ADDENDUM NO. 2

**South River Fish Passage and
Veterans Memorial Park Improvements Project
Marshfield, MA**

September 11, 2024

Fuss and O'Neill, Inc.
317 Iron Horse Way, Suite 204
Providence, RI 02908

SUBMERSIBLE PUMP STARTER WIRING DIAGRAM
NOT TO SCALE

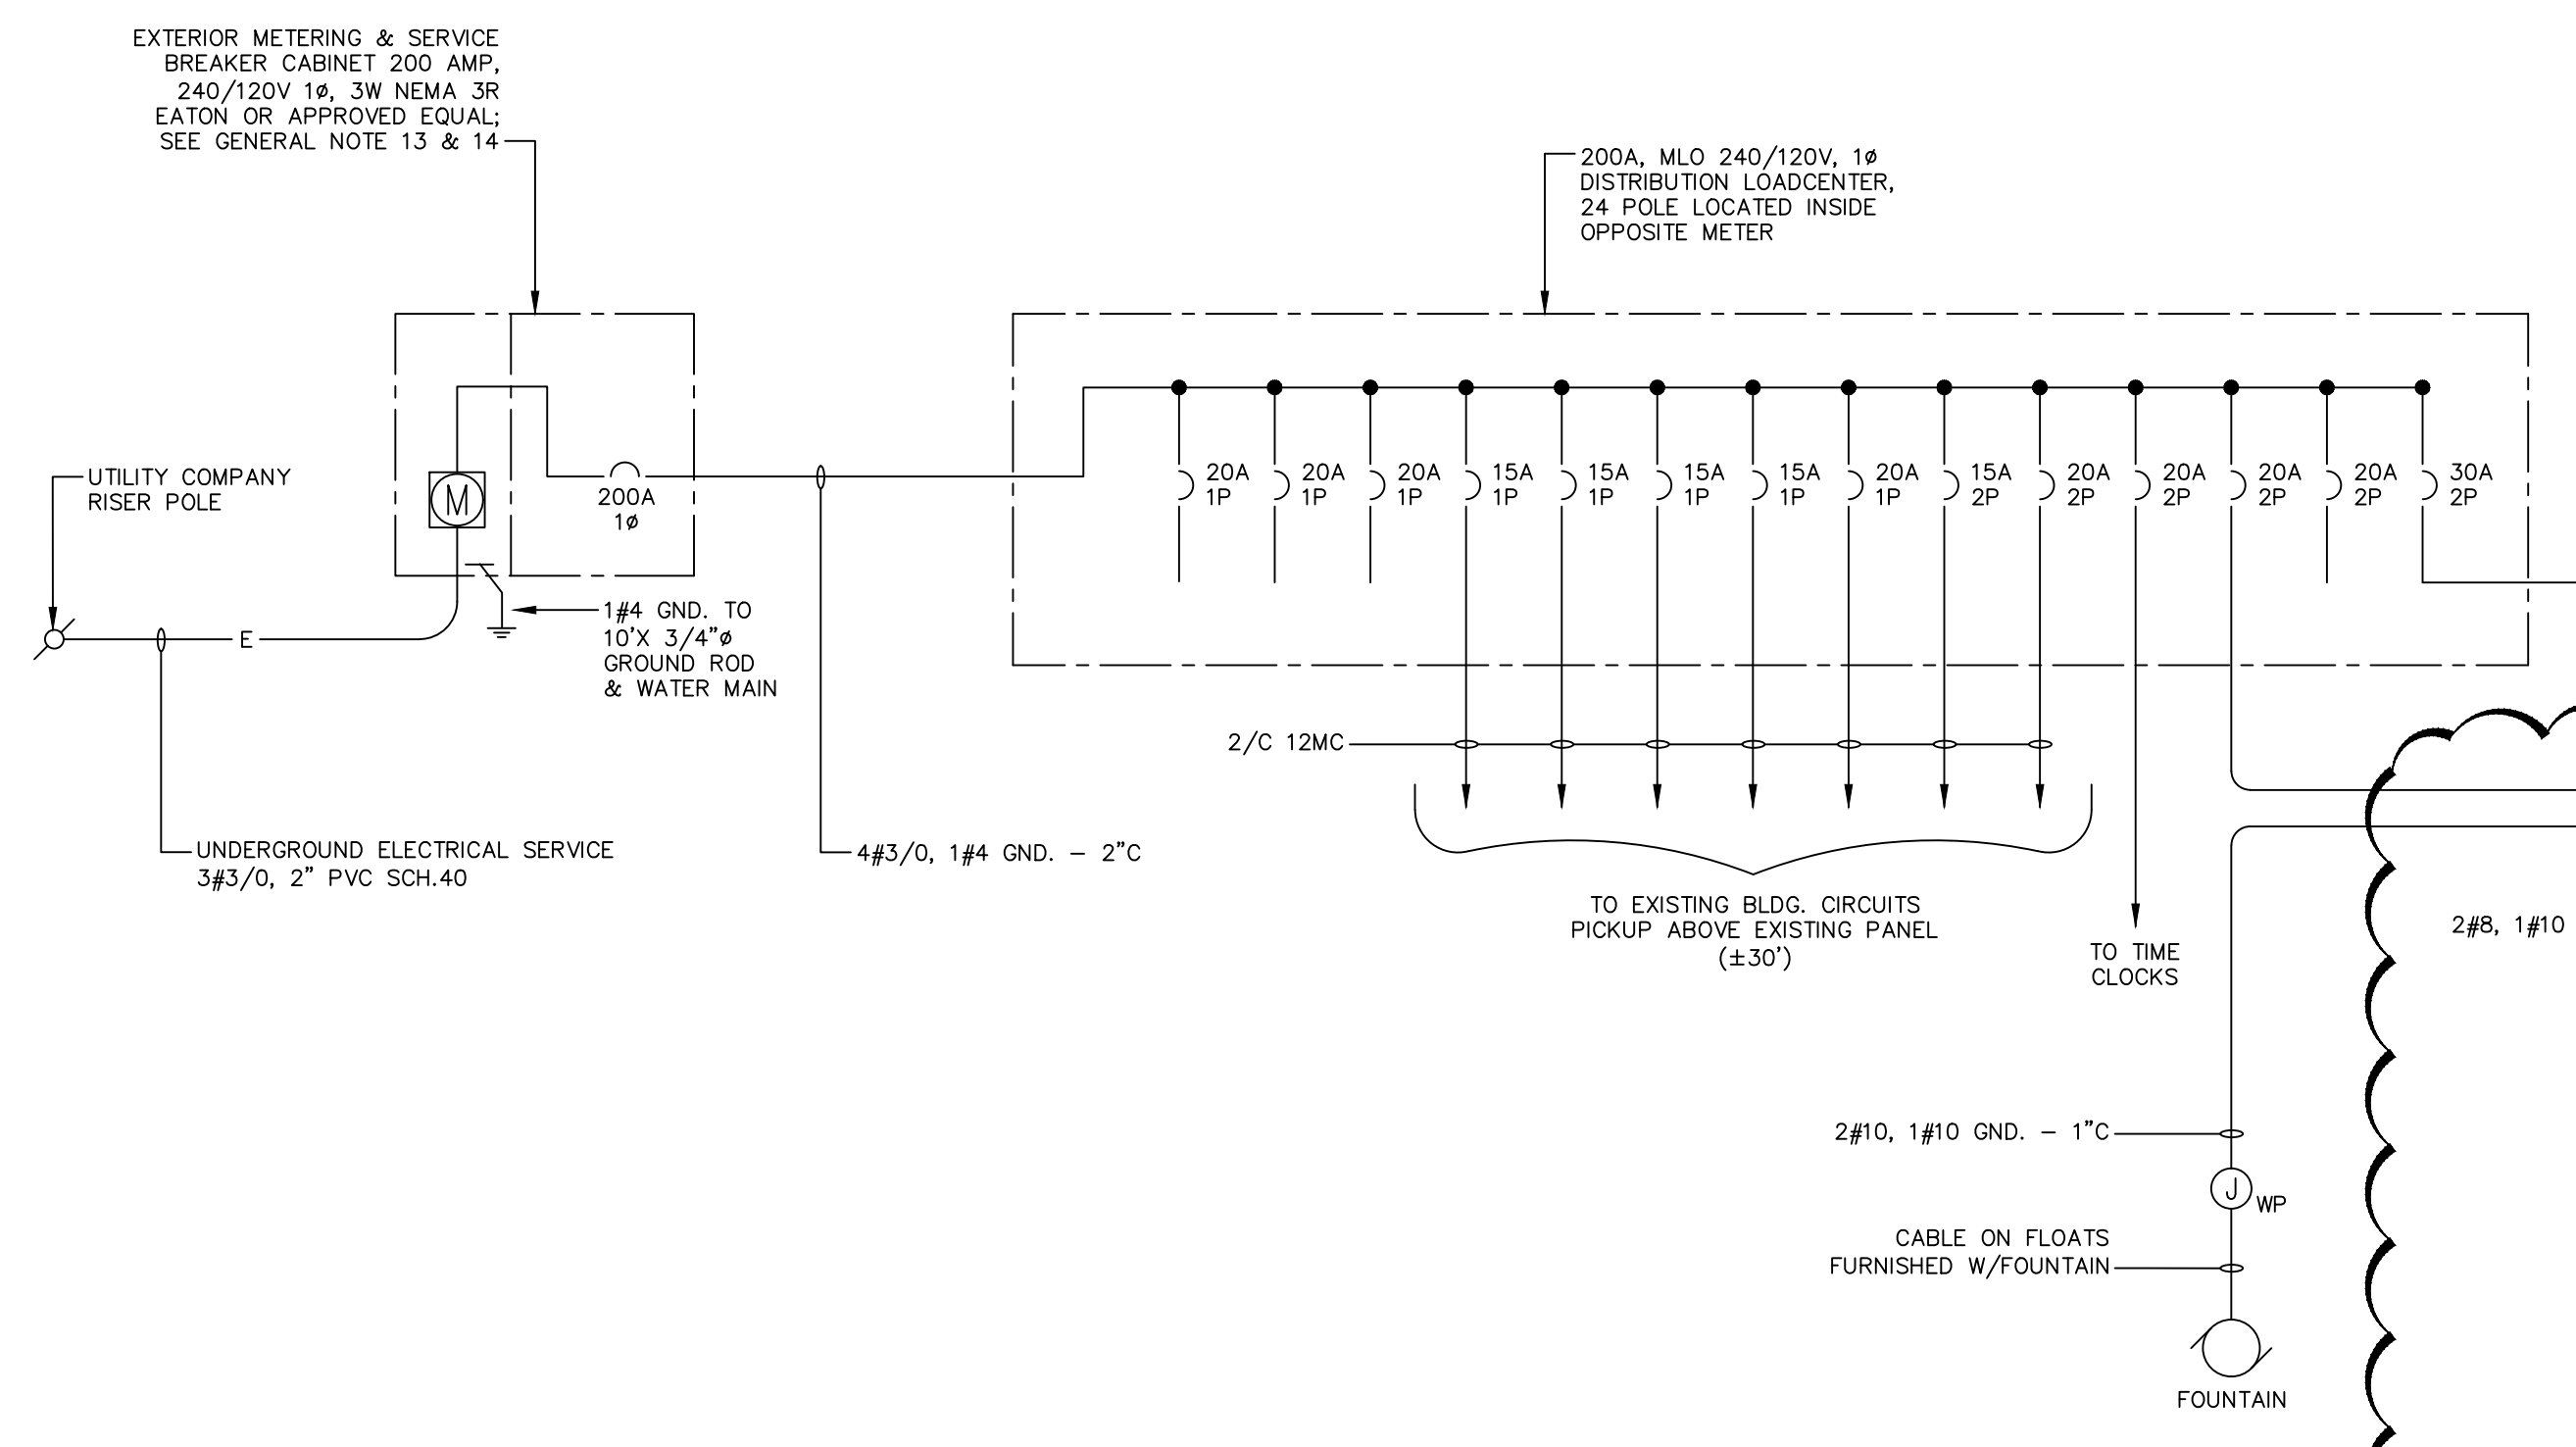
5. Delete Sheets CS-105, CD-502, CD-503, and CD-508 of the Contract Drawings and replace with respective revised sheets provided in Attachment C.
 - A. Sheet CS-105 and CD-502 depict a conversion of the 8” blowoff pipe to ductile iron and a revised lagoon outlet control structure, Sheet CD-503 depicts the addition of a submersible pump detail, and Sheet CD-508 depicts the addition of anticipated pump on/off elevations for the proposed level transmitters (note that these elevations will be reviewed in the field during construction and may be adjusted by the Town).

Please refer to Items 4 and 5 above. Note that there is only one pump called for on Sheets CS-105 and CD-508. Note also that a revision on Sheet CS-105 indicates that the pipe connecting the cisterns is 6" diameter and at EL 3.0.
